Service Information

+Category N	Repair Guidance	Ref. No. R070/13	Page 1 of 2
Coverage <input type="checkbox"/> Distributor only <input checked="" type="checkbox"/> Please inform your dealers		Date Issued September 17, 2013	
Please convey this information to your <input type="checkbox"/> Director <input checked="" type="checkbox"/> General Manager <input checked="" type="checkbox"/> Warranty Dept. <input checked="" type="checkbox"/> Parts Dept. <input checked="" type="checkbox"/> Training Dept. <input checked="" type="checkbox"/> Field Rep.		Date Revised	
Applicable Model CX-5 (KE)		Applicable Countries or Specifications Worldwide

Subject: Unusual noise when vehicle is started with steering wheel fully turned to driver-seat side

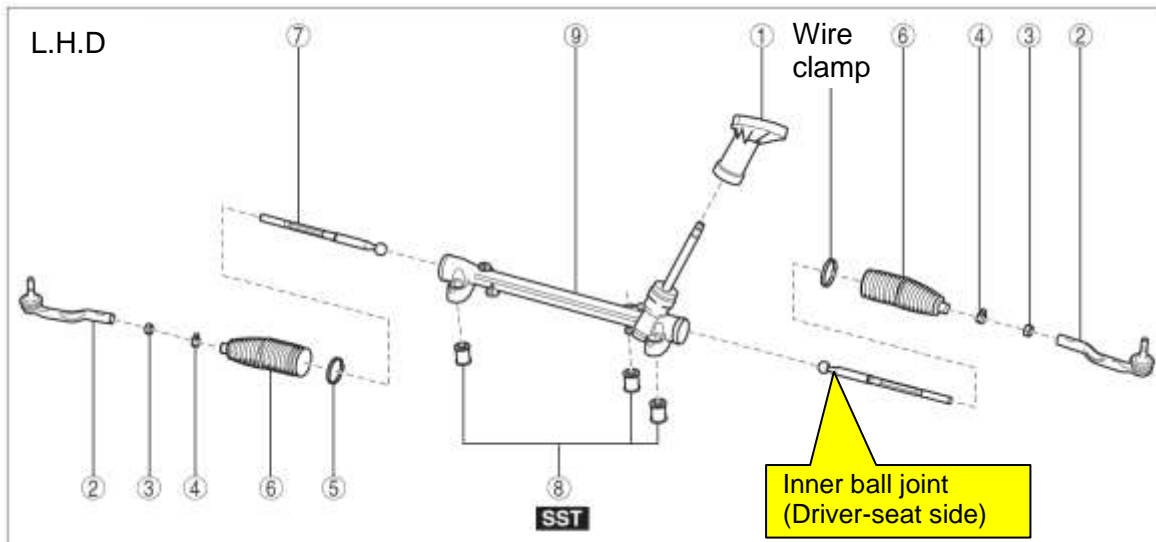
An edge of the inner ball joint at the driver-seat side may get stuck with the steering gear housing, causing a stick-slip noise.

The shape of the inner ball joint edge has been changed.

1. Verify customer complaint.
 - ① Stop the vehicle after the steering wheel is fully turned to the direction where the driver's seat is installed.
 - ② Verify that the noise occurs when starting the vehicle.
Note: Refer to the noise sample in the attached video file.
2. If the noise is reproduced, remove the steering gear and linkage from the vehicle according to the Workshop Manual "STEERING GEAR AND LINKAGE REMOVAL" and replace the inner ball joint (driver-seat side) with a modified one according to the Workshop Manual "STEERING GEAR AND LINKAGE DISASSEMBLY".
3. Install the steering gear and linkage in the reverse order of removal.
4. Verify the repair.

Part Number		Part Name	Q'ty	Remark
New	Old			
KD31 32 240A	KD31 32 240	Inner Ball Joint	1	
BBM4 32 127		Wire Clamp	1	R Replace part See the illustration in the 1 st page for the location.
B455 32 099B		Joint Bolt	1	R Replace part (Joint bolt between intermediate shaft and steering gear & linkage assembly)
T060 26 169A		Snap Pin	2	R Replace part (Snap pins for outer ball joint (tie rod end))-both sides
